Planning & Development Consultants
63 York Road
Dun Laoghaire
Co. Dublin
www.brockmcclure.ie

08 June 2022

**Additional Information Response for Planning Application by Cedarglade Ltd.
Main Street, Newcastle, Co. Dublin (Reg. Ref. SD21A/0311)**

Access from Car Park to Community Centre Void of steps

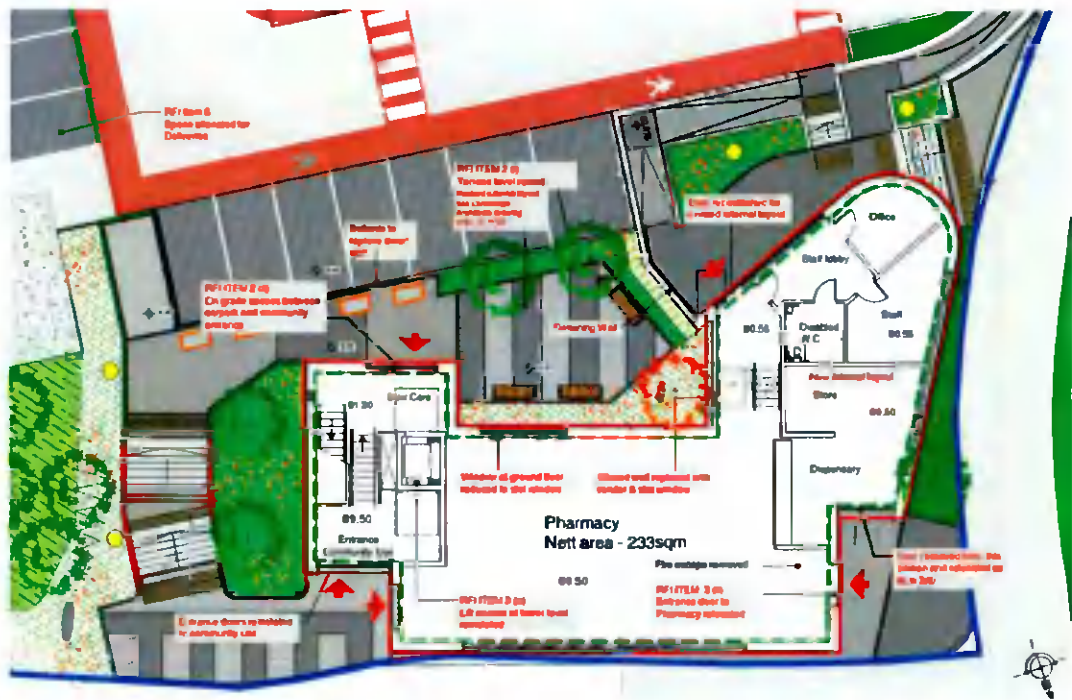
- (b) *the access from the car park to the community space entrance should be clearly demonstrated in plan form to provide a pathway to the community centre void of steps and obstacles for the mobility impaired.*

Response: We refer the Planning Authority to the attached drawings by MCA Architects that illustrate the almost level access between the car park and the entrance to the community centre. The level difference is 0.1m which can be accommodated through a slight sloping of the pavement. A ramped access is then provided to the pharmacy use from the car park. We trust this is to the satisfaction of the Local Authority.

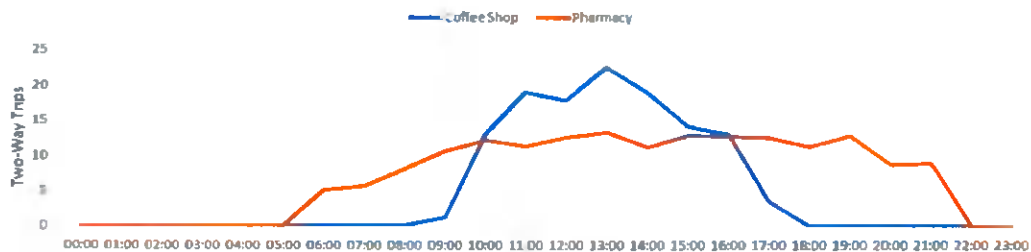
The Planning Authority has concerns that the proposed pharmacy use will result in a different dynamic than that created by a cafe /community centre, which was initially assessed in previous planning permission. The pharmacy is likely to generate additional deliveries and will generate 'quick-stop' journeys to collect medication. Having regard to the proposed change of use and the nature of the use, the applicant is requested to explore both these issues and submit revised proposals that demonstrate that considerations has been given to loading of deliveries and providing ease of access for quick collections from Main Street and confirm if on-street car parking can be provided. In this regard, the applicant should liaise with the Roads Department.

Response: We refer the Planning Authority to the attached details by MCA Architects that indicate The SuperValu car park layout has been revised to show a designated parking space for deliveries to the proposed pharmacy which can be accessed from the rear. There is no restricted access from SuerValu to the proposed pharmacy.
